UNITED STATES PATENT AND TRADEMARK OFFICE

APPLICATION NO.	FILING DATE	FIRST NAMED INVENTOR	ATTORNEY DOCKET NO.	CONFIRMATION NO.
10/699,450	10/31/2003	Venkata A. Bhagavatula	SP02-275	2835
22928	7590	11/29/2005	EXAMINER	
CORNING INCORPORATED			ROJAS, OMAR R	
SP-TI-3-1			ART UNIT	
CORNING, NY 14831			PAPER NUMBER	
			2874

Office Action Summary

DETAILED ACTION

Figure 4 of Thual is reproduced below.

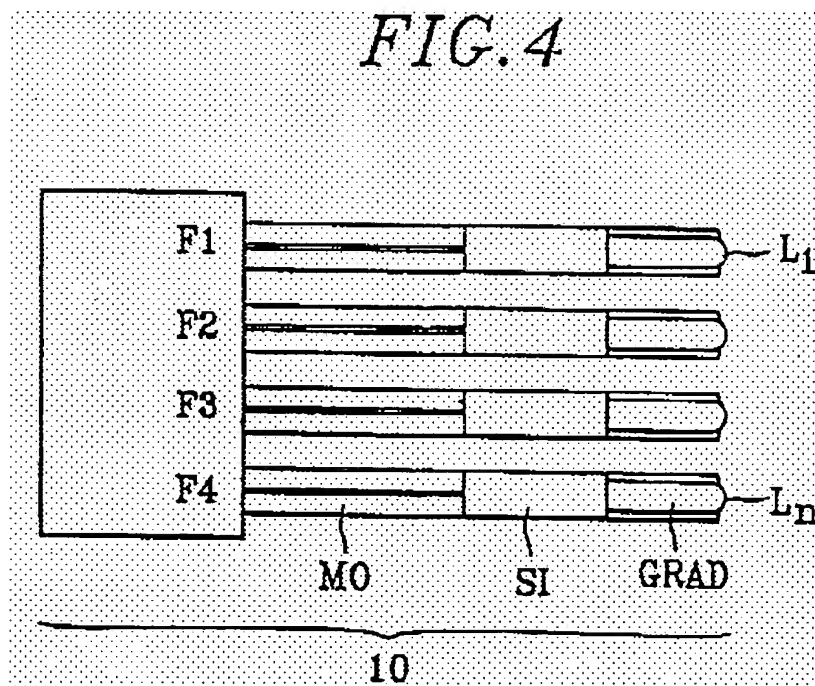
Regarding claims 1, 5, and 21, Thual discloses a fiber lens (e.g., see Figure 4), comprising:

a graded-index lens ("GRAD");

a single-mode fiber ("MO") disposed at a first end of the graded-index lens;

a refractive lens ("L₁") having a hemispherical shape formed at a second end of the graded-index lens ("GRAD") to focus a beam from the single-mode fiber to a diffraction-limited spot; and

a spacer rod ("SI") interposed between the graded-index lens ("GRAD") and the single-mode fiber ("MO").

Thus, Thual only differs from claims 1, 5, and 14, in that Thual does not teach a hyperbolic shape.

The Edwards article, however, teaches that lenses with hyperbolic shape are superior to lenses with hemispherical shape (see Abstract). Thus, modifying the hemispherical lens L_1 in Thual to have a hyperbolic shape would have been desirable in view of Edward's teachings.
